SERVICE CAMPAIGN BULLETIN

TITLE:	Wheel Speed Sensor Harness Update
CAMPAIGN REFERENCE:	03X
DOCUMENT NUMBER:	11 B 013
AFFECTED VEHICLES:	McLaren 675LT
SITUATION:	Quality Engineering at McLaren have identified that the rear wheel speed sensor harness is not routed in the best possible position. Two extra clips have been added to directly route the rear wheel speed sensor harness.
PROCEDURE:	Please follow the instructions outlined in this document to update the routing of both rear wheel speed sensors.

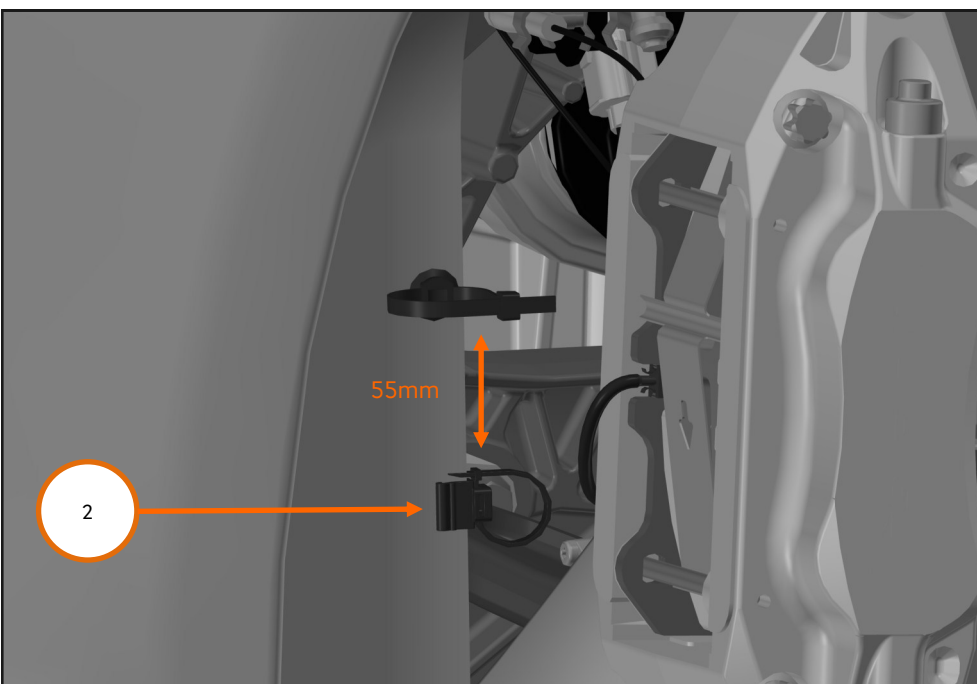
1. Install 00RL001 Fir Tree Clip (1) in to the existing hole in the wheel arch liner.

2. Install 00RL022 Edge Clip (2) 55mm below the Fir Tree Clip, do not fully secure the cable ties at this stage.

Care Point: The wheel speed sensor harness **must** be horizontally orientated when secured with the Edge Clip cable tie.

3. Use the 'M' of the McLaren logo (3) as a marker to position the Edge Clip cable tie.

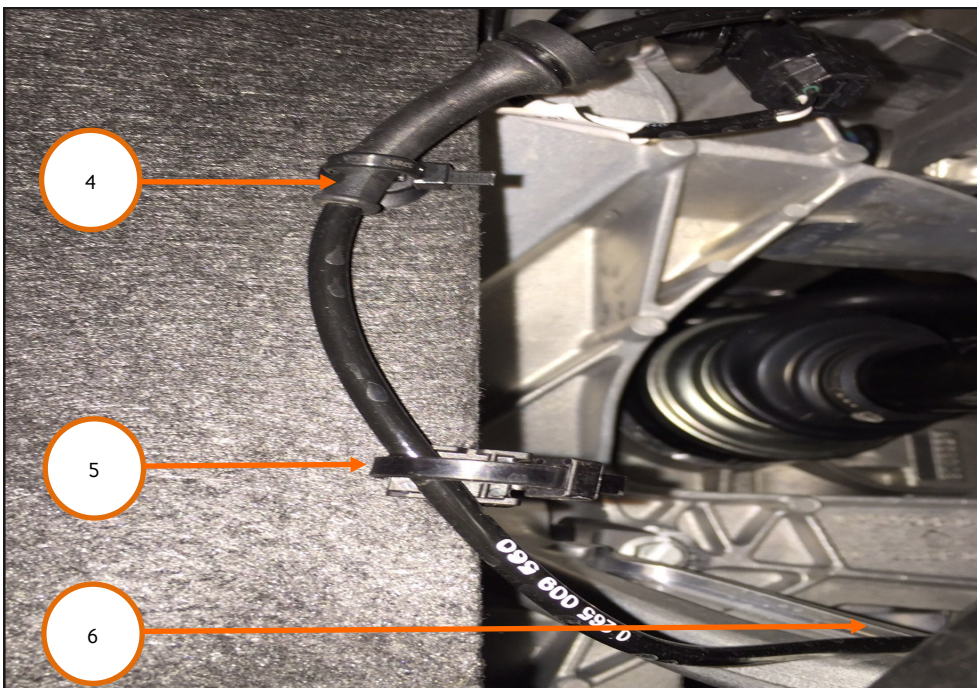
4. Secure the Fir Tree cable tie around the rubber sheath (4). Ensure the sensor harness is horizontally orientated, then secure the Edge Clip cable tie (5).

5. Ensure the wheel speed harness is not in contact with the wishbone (6).
